**APPEAL HEARING
STAFF REPORT
KETCHUM PLANNING AND ZONING COMMISSION
SPECIAL MEETING OF JUNE 8, 2017 at 2:00 PM**

APPEAL: #17-027
Appeal of Administrator's decision to reject a resubmitted application for a Conditional Use Permit (CUP) for a Motor Vehicle Fueling Station with accessory food service located at 911 N. Main Street (Ketchum, AM Lot 5A, Block 30)

IN RE:)	
)	
Bracken Station Motor Vehicle)	
Fueling Station and Food Service)	
Conditional)	
Use Permit)	KETCHUM PLANNING AND ZONING COMMISSION
)	FINDINGS OF FACT, CONCLUSIONS OF LAW AND
)	DECISION
File Number: 16-034)

FIGURE 1: SUMMARY OF CRITERIA A thru G shown on Site Plans

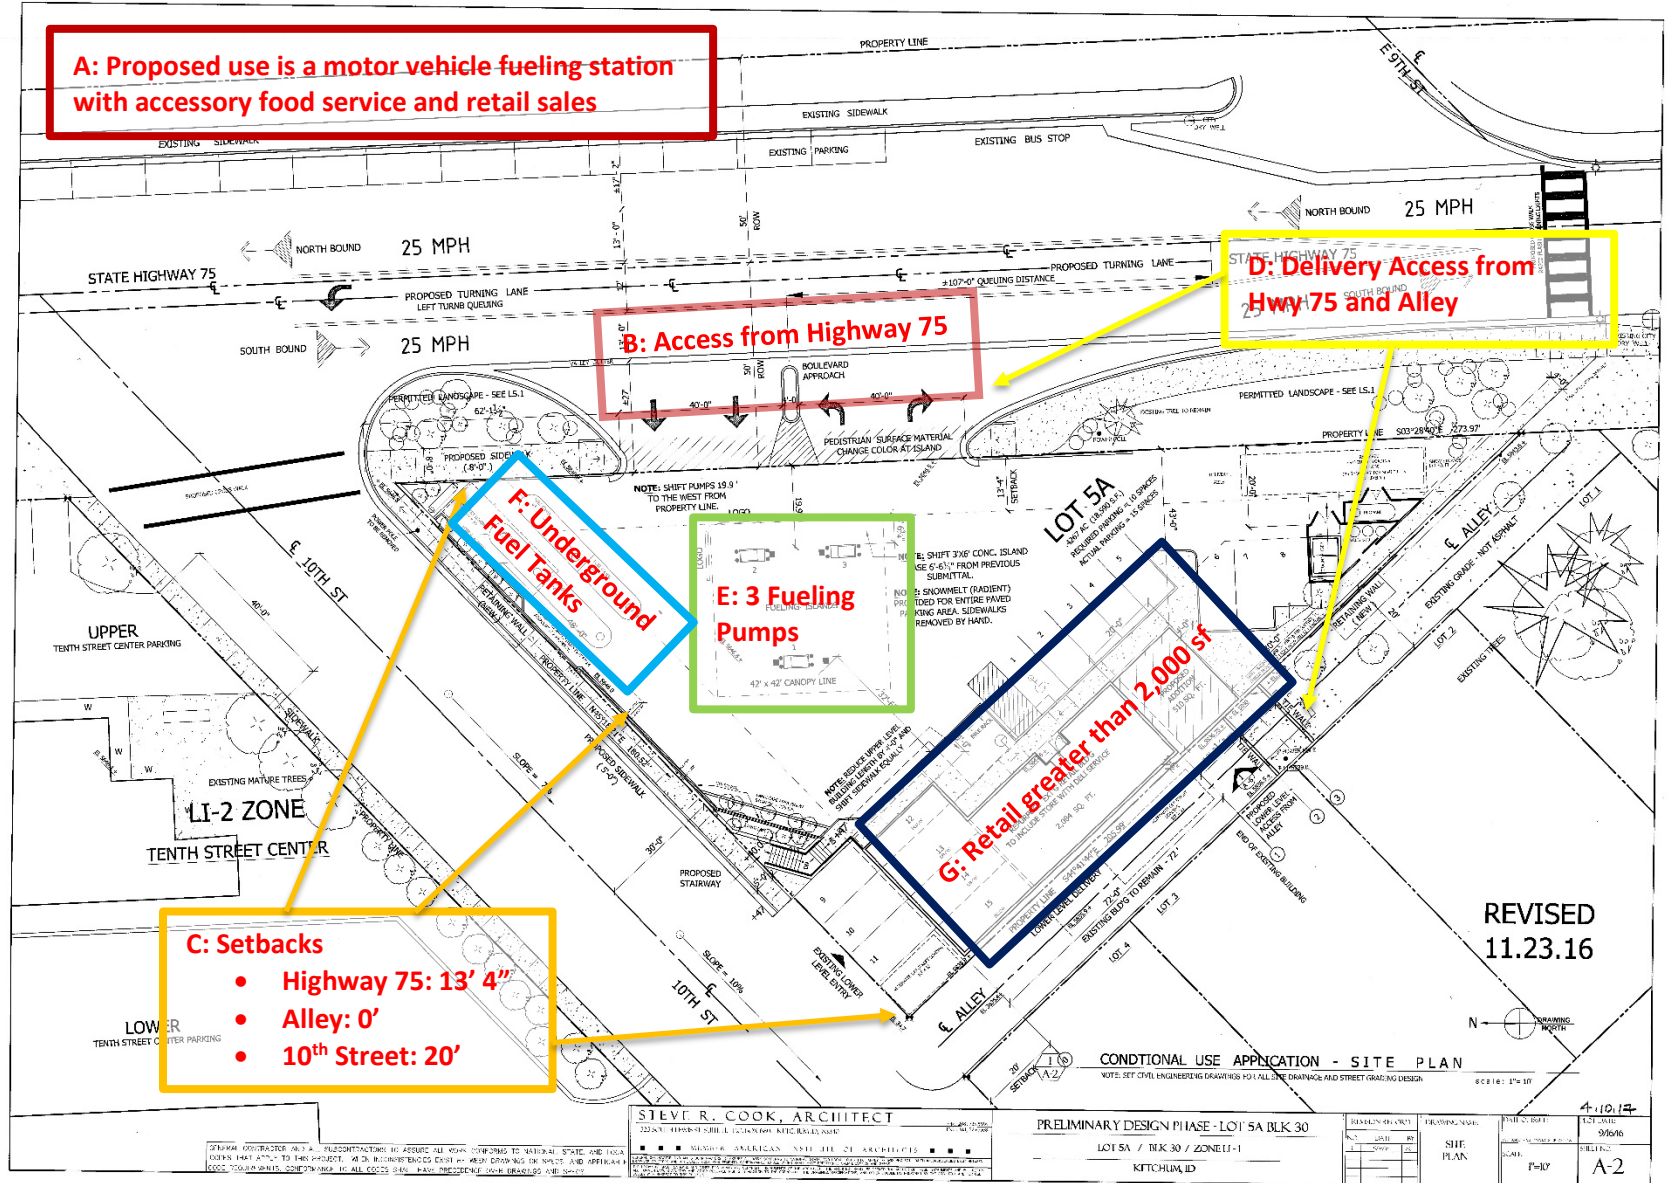
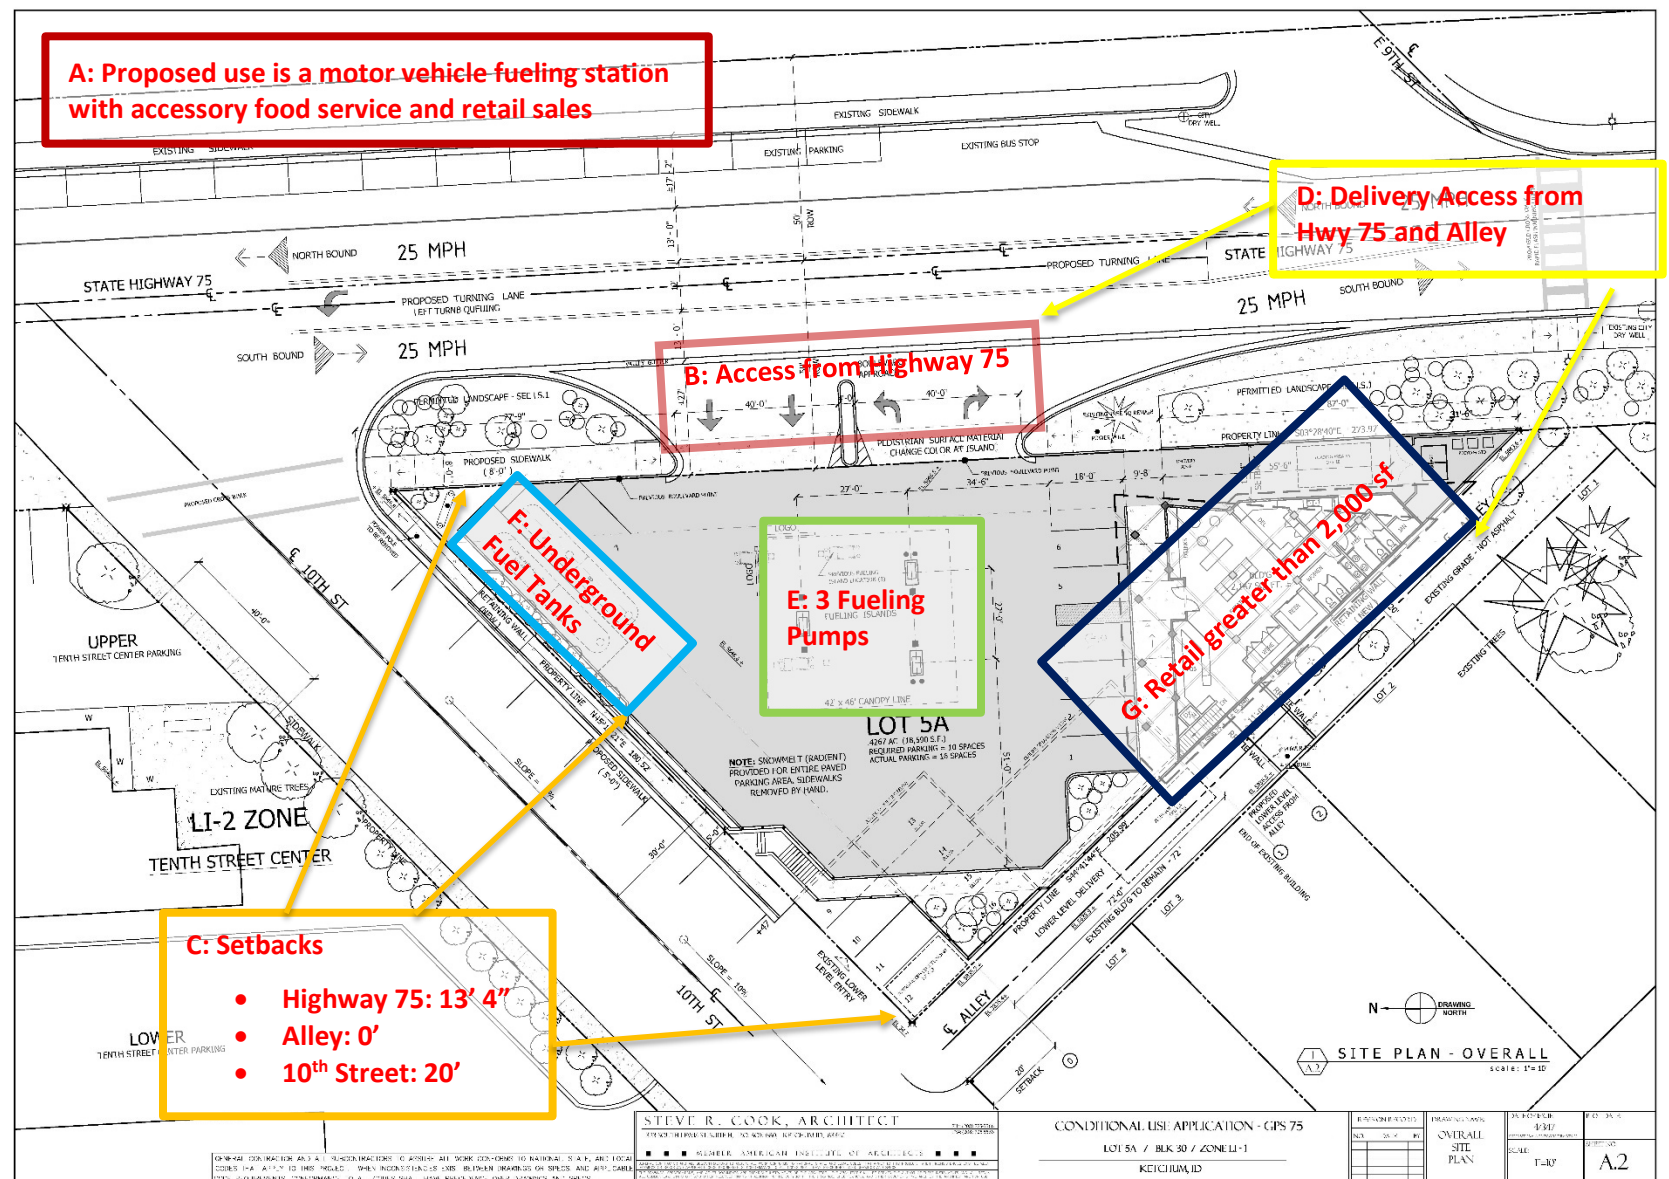
4. The Administrator made this determination based seven principal elements of the applications, listed below as Criteria A thru G. Table 1 summarizes these criteria. Figure 1 illustrates Criteria A thru G on the 2016 plan and the resubmitted plan.

A.	Use Proposed	<ul style="list-style-type: none"> Motor Vehicle Fueling Station with accessory food service and incidental retail sales 	<ul style="list-style-type: none"> Motor Vehicle Fueling Station with accessory food service and incidental retail sales 	Yes

B.	Access	<ul style="list-style-type: none"> Accessed from Highway 75 	<ul style="list-style-type: none"> Accessed from Highway 75 	Yes
C.	Setbacks	<ul style="list-style-type: none"> Highway 75: 13' 4" Alley: 0' 10th Street: 20' 	<ul style="list-style-type: none"> Highway 75: 13' 4" Alley: 0' 10th Street: <20' 	Yes

D.	Delivery Access	<ul style="list-style-type: none"> Highway 75 and Alley 	<ul style="list-style-type: none"> Highway 75 and Alley 	Yes
E.	Number of fueling pumps	<ul style="list-style-type: none"> 3 fueling pumps 	<ul style="list-style-type: none"> 3 fueling pumps 	Yes

F.	Underground Fuel Tank Locations	<ul style="list-style-type: none"> Northern corner of lot 	<ul style="list-style-type: none"> Northern corner of lot 	Yes

G.	Square footage of retail establishments	<ul style="list-style-type: none"> Greater than 2,000 square feet 	<ul style="list-style-type: none"> Greater than 2,000 square feet 	Yes

1. Based on the evaluation of Criteria A thru G as summarized in Table 1, the Administrator concluded the resubmitted application was the “same or substantially” the same and the application was denied.
2. The applicant has a right to file the “same or substantially” the same application on or after February 13, 2018.

REVISED
11.23.16

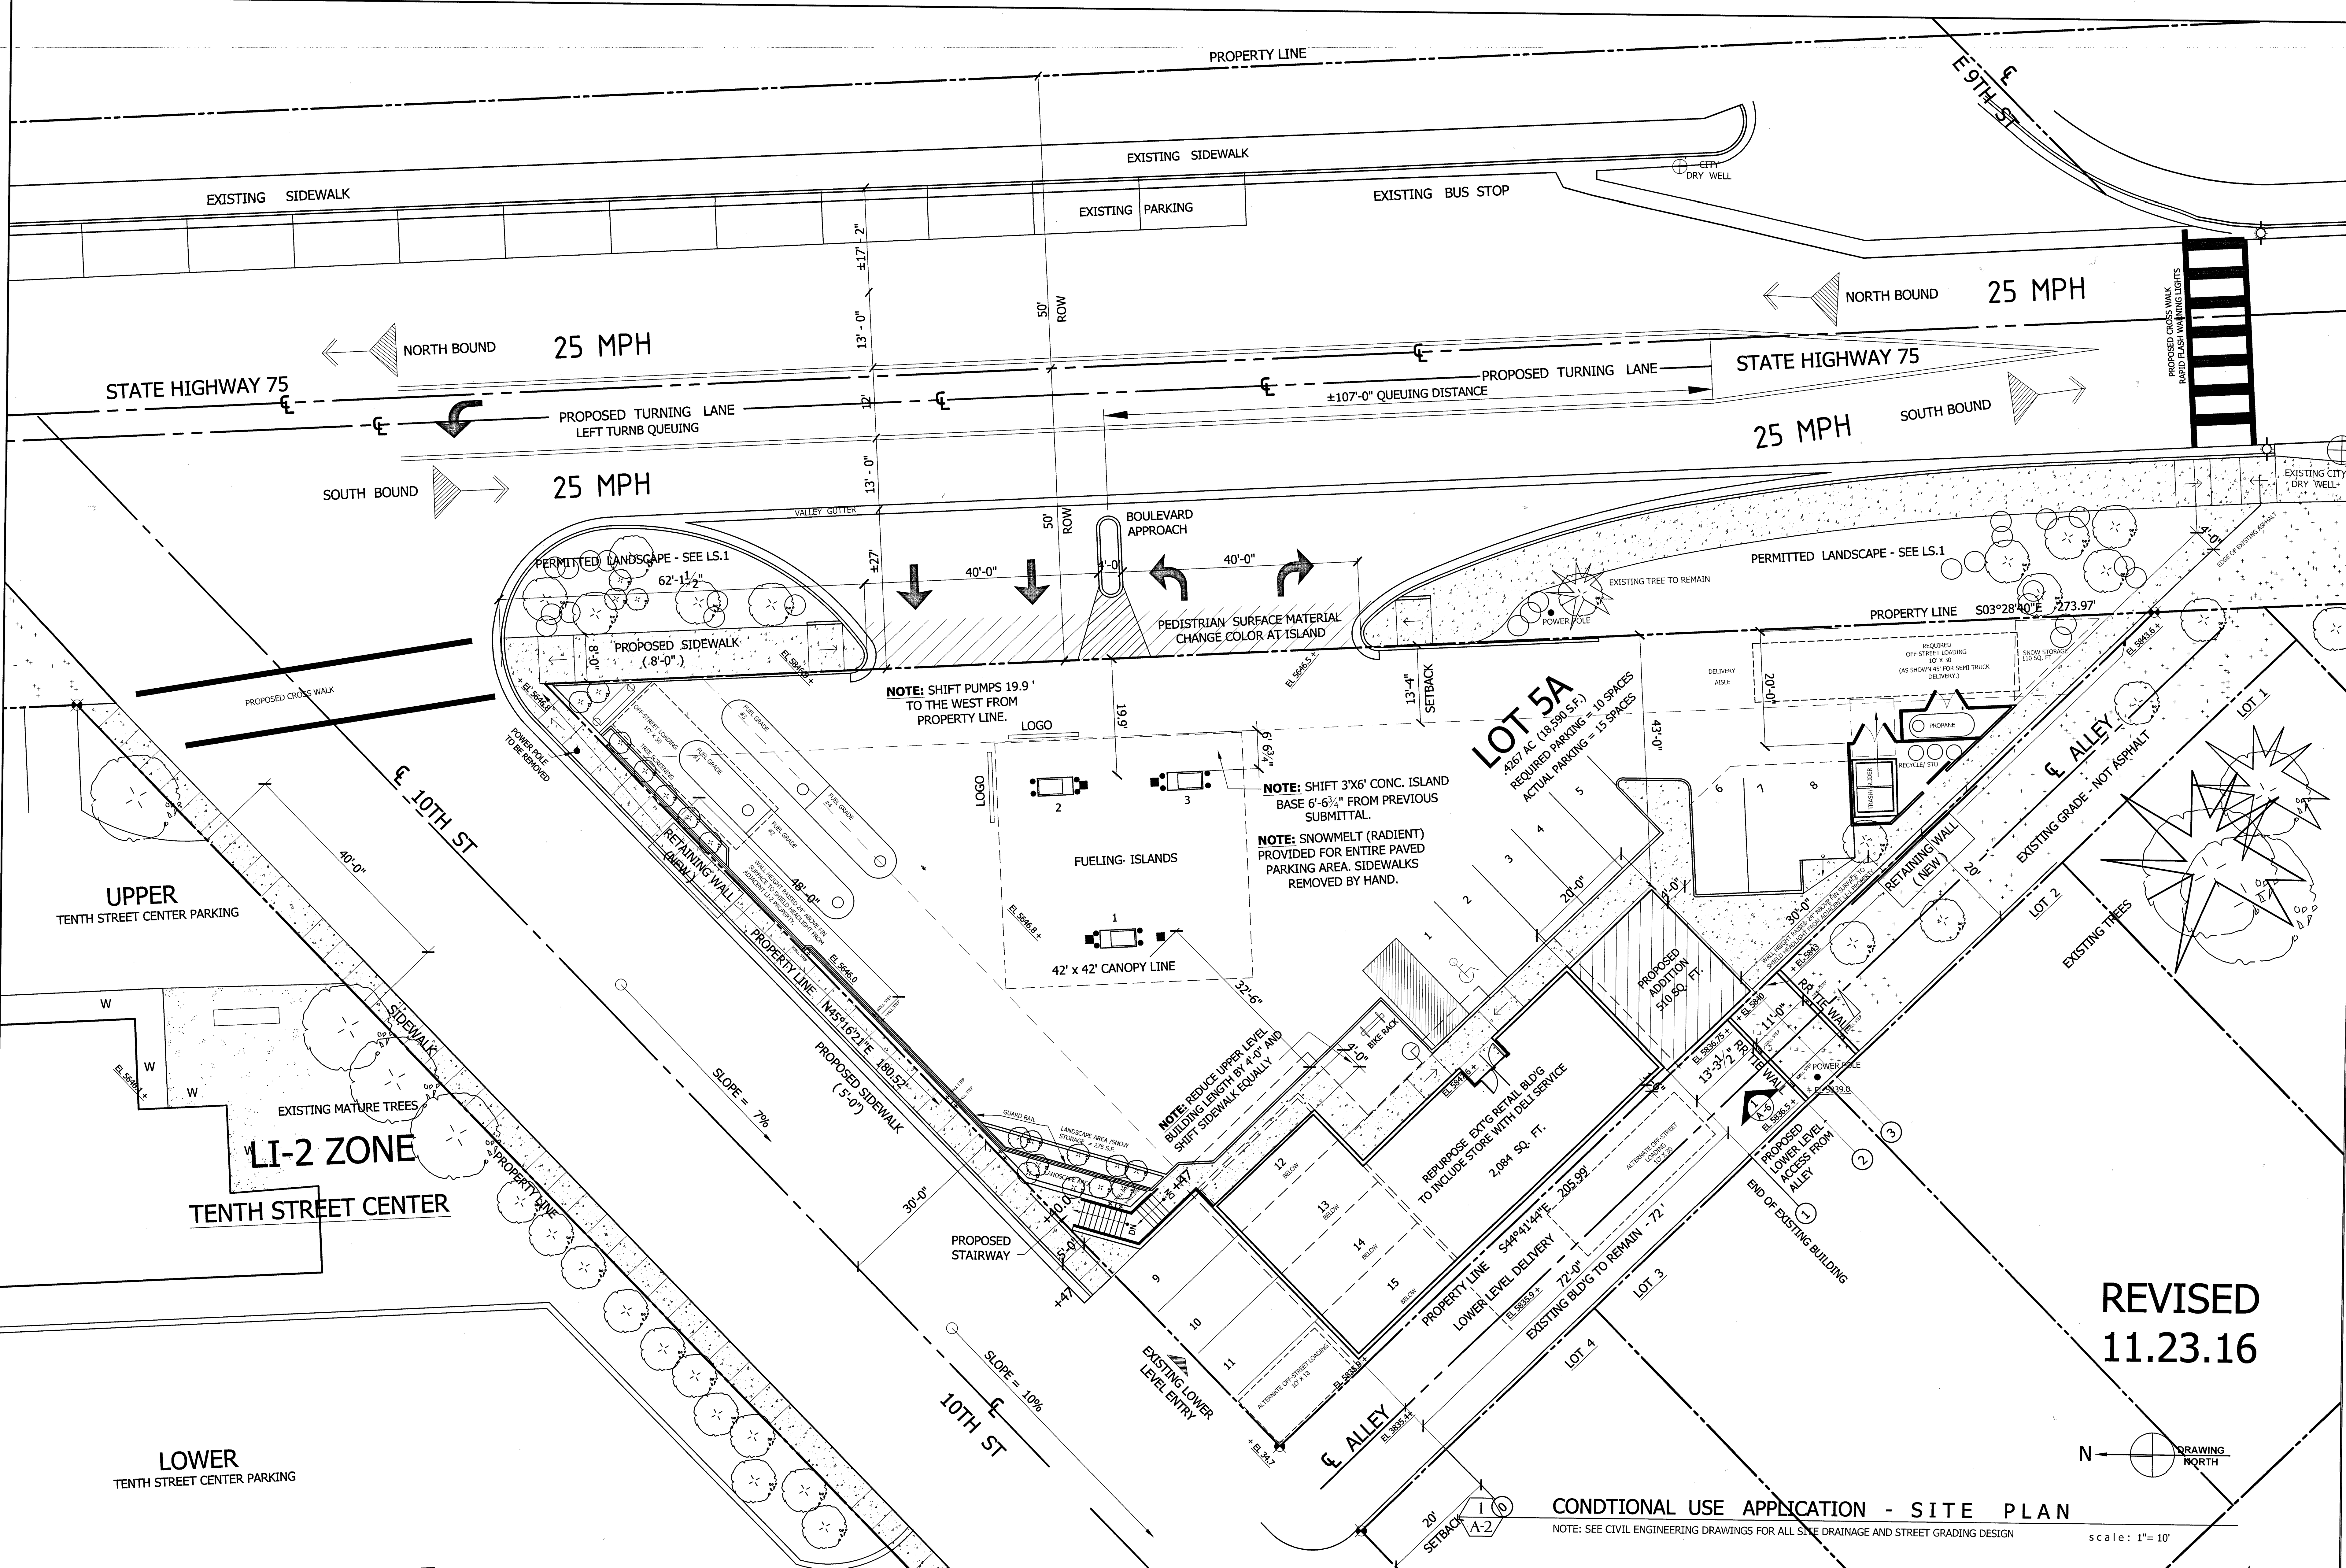
Findings pertaining to revised Site Plan dated November 23, 2016	
1. Boulevard Approach	1. In addition to the change in surface material across the boulevard approach in the pedestrian zone a new change in surface material was proposed at the island that bisects the boulevard approach.

2. Eastern Fuel Pumps	1. The eastern two fuel pumps were shifted 6'-6 3/4" further west. The fuel pumps were previously located 13'-4" from the western property line, these fuel pumps are now 19'-9" from the western property line.

3. Western Fuel Pumps	1. One of the western fuel pumps was removed. The remaining western fuel pump was relocated and centered between the northern and southern edges of the canopy.

4. Fueling canopy	1. The fueling canopy was enlarged from 40'-6" x 40'-8" to 42' x 42'. 2. The fueling canopy was shifted 3' to the west. The eastern setback from the property line is now 13'-4", with no overhang of the canopy into the setback.

5. Building	1. The eastern façade of the building was shifted 4' to the west on the northernmost portion of the building.

6. On-site pedestrian circulation	1. The on-site sidewalk adjacent to the northernmost portion of the eastern façade of the building was shifted 4' west.

7. Landscaping and Landscape Walls	<p>1. The tree screening buffer adjacent to the northern (10th Street) property line was reduced; the westernmost trees were removed.</p> <p>2. A 24" landscaping wall was proposed for the area where the tree screening was removed.</p> <p>3. A 24" height landscaping wall was proposed along a portion of the southwestern property line to provide a buffer from vehicle headlights. The proposed wall extends 30' from the southernmost edge of the building.</p>

8. Snow Storage	1. The applicant proposed to snow melt the entire paved parking and circulation area of the site and to manually remove snow from the sidewalks. There is 275 square feet of snow storage provided in the landscape area adjacent to the pedestrian staircase, 200 square feet of snow storage provided near the entrance to the building, and 110 square feet of snow storage is provided in the southeast corner of the property, for a total of 585 square feet of on-site snow storage. This snow storage space is reserved to accommodate snow removed from the on-site sidewalk network; approximately 50% of the on-site pedestrian sidewalk area is not covered by roof overhang.

9. Off-Street Loading	<p>1. The applicant proposed one off-street loading space 10' x 30' in size at the northeast corner of the site and one off-street loading space 10' x 45' in size at the southeast corner of the site. Two off-street loading spaces are required.</p> <p>2. The applicant proposed one alternate loading space 10' x 30' in size in the alley to the west, at the lower level of the site and one alternate loading space 10' x 18' in size at the lower level of the site, adjacent to 10th Street.</p>
